WCAP-16078-NP-A

**Westinghouse BWR ECCS
Evaluation Model:
Supplement 3 to Code Description,
Qualification and Application to
SVEA-96 Optima2 Fuel**

SUBJECT: FINAL SAFETY EVALUATION FOR TOPICAL REPORT WCAP-16078-P,
"WESTINGHOUSE BWR ECCS EVALUATION MODEL: SUPPLEMENT 3 TO
CODE DESCRIPTION, QUALIFICATION AND APPLICATION TO SVEA-96
OPTIMA2 FUEL" (TAC NO. MB8908)

Figure 3-1 Flow of Information Between Computer Codes

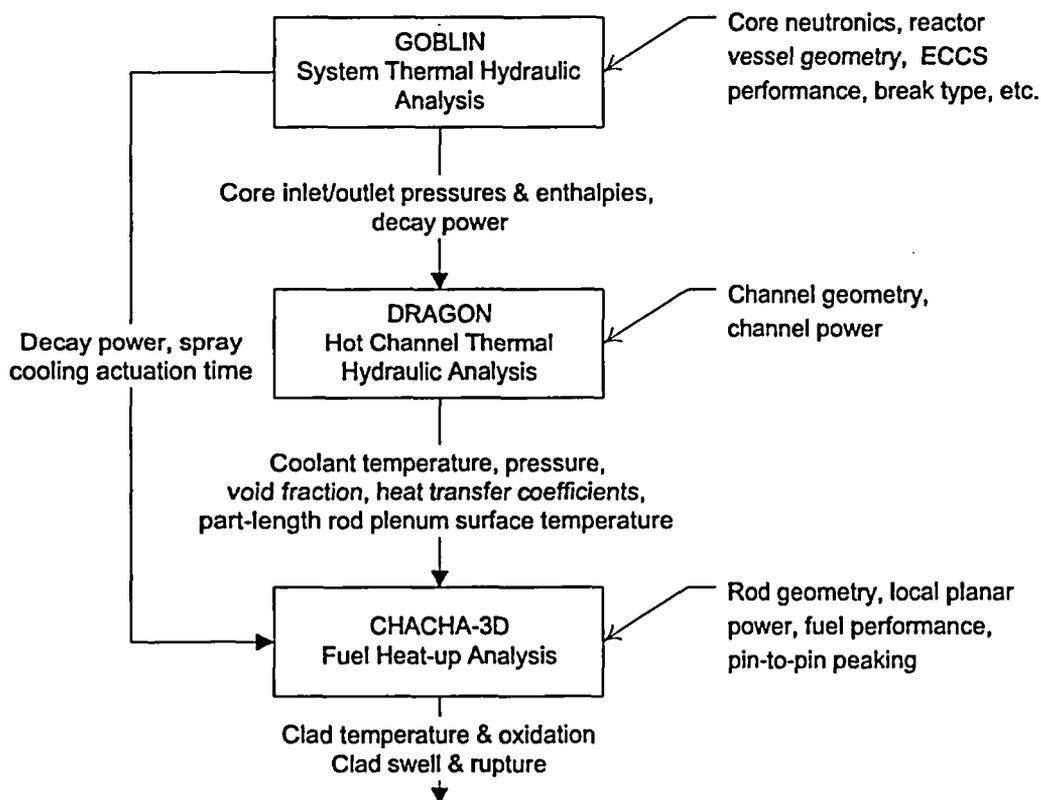
Figure 3-1 shows the flow of information between computer codes. Please clarify whether all three code run independently during every time step of calculation. In other words, does DRAGON and CHACHA-3D provide feedback to the GOBLIN to affect the system wise solution schemes. If DRAGON and CHACHA-3D only perform side calculations based on the boundary conditions provided by GOBLIN, how is the energy generation due to metal-water reaction considered in the GOBLIN?

As indicated in Figure 3-1 of WCAP-16078-P, GOBLIN is run to determine the boundary conditions for the hot channel analysis (DRAGON). Then DRAGON is run to determine the boundary conditions for the fuel heat-up analysis (CHACHA). There is [
